BPW NEWS BPW BERGISCHE ACHSEN

BPW ECO Drum for axle stub MVBFST 10010 with brake SN 4218 Your decisive advantage in the transport business

Initial equipment for axle stub MVBFST 10010 from 07/2008

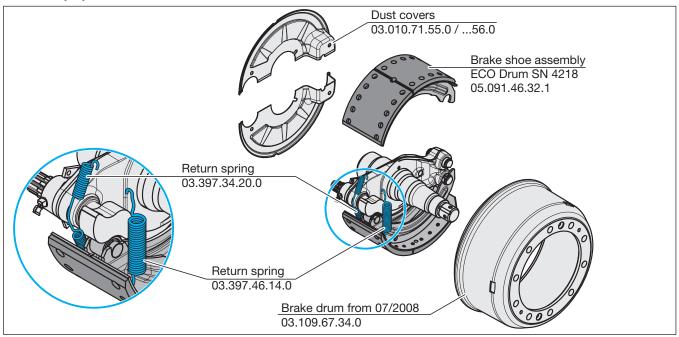
From July 2008, axle stubs MVBFST 10010 with brake SN 4218 installed by OEMs will receive the enhanced technology of the ECO Drum brake (for ECO Drum see also BPW NEWS TB 7142709d).

Positioning of one-piece return spring 03.397.34.20.0 on the outer contour of the brake mounting plate

Replacement for axle stub MVBFST 10010 up to 06/2008

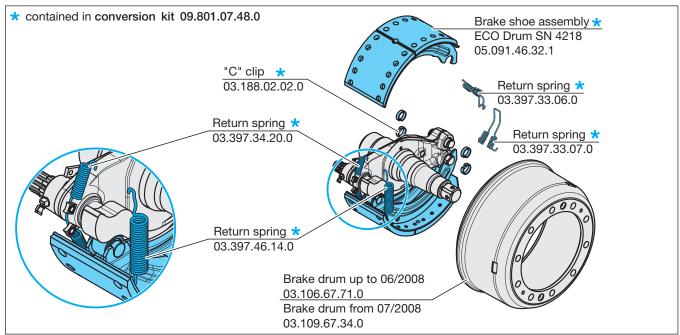
Previous axle beam versions (up to build year 06/2008) are retrofitted with ECO Drum brake shoes SN 4218 and the new return springs 03.397.34.20.0 and 03.397.46.14.0 when they come in for service. No groove is required in the brake anchor plate for the retrofit, because the middle part of the return spring 03.397.34.20.0 makes contact with the contour of the weld-on nuts and is therefore fully located.

When axle stub versions produced up to and including June 2008 come in for service, they must be equipped with the **conversion kit 09.801.07.48.0** (new brake shoe assemblies, "C" clips and return springs). Brake drum 03.106.67.71.0 can be replaced by brake drum 03.109.67.34.0.

Fit new return springs and "C" clips every time the brake linings are changed!
